| PROJECT:<br>BOYLE MI |                  | SHEET NO.<br>1/10 |
| BY:<br>CUF           | DATE:<br>5/31/18 | JOB NO.<br>17147  |

SEE SHEETS S1.0 S1.1 S2.1 S2.2 S2.3 S3.1 S3.2 FOR REFERENCE  
NUMBERS  
- ATTACHED

SHEET S1.0

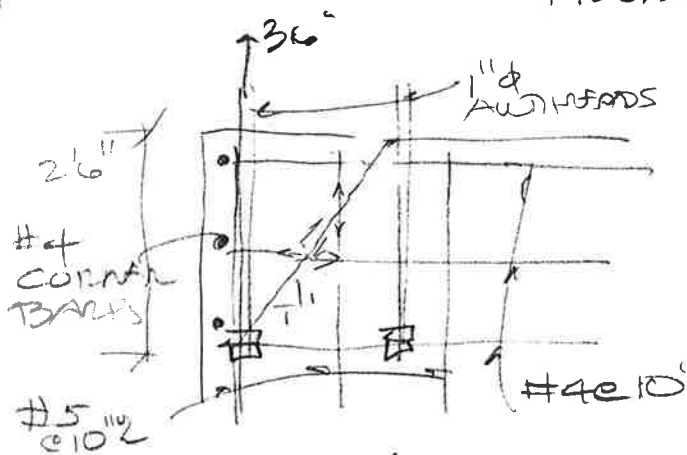
- 1) SEE SHORING DESIGN BY OTHERS
- 2) SEE ADD'D STEEL SPECIAL INSPECTION
- 3) LEGIBLE TABLES PROVIDED

STREET 52.2

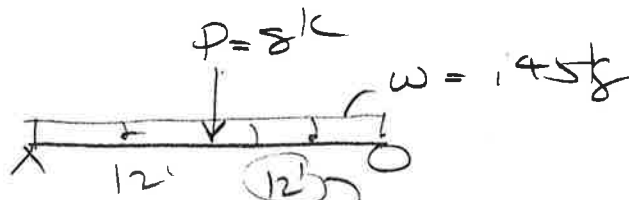
1) BEAM B3 SHOULD BE 5 1/2" x 24" GLULAM

$$R_0 = \frac{\sqrt{178(12)^2}}{55^2} = 13.0$$

$$F_{BE} = \frac{16(1.80000)}{13.0^2} = 6497 \text{ psi}$$

$$F_{BE} = \frac{6497}{2760} = 2.35$$

$$M = \left( \frac{45(24)^2}{8} + \frac{8(24)}{4} \right) \frac{12}{176} = 1005$$

$$C_L = \frac{1 + 2.35}{1.9} - \sqrt{\left( \frac{1 + 2.35}{1.9} \right)^2 - \frac{2.35}{175}} = 1.96$$

$$S_{FE} = \frac{1005}{2.4(1.15)} = 364 \text{ in}^3$$

HORIZONTAL LOAD

$$M = \frac{1.4(16)^2}{8} \frac{12}{12} = 54 \text{ k-in}$$

$$S_{FE} = \frac{54}{1.55(1.6)} = 18.2 \text{ in}^3$$

5 1/2" x 24" GLULAM  
OK
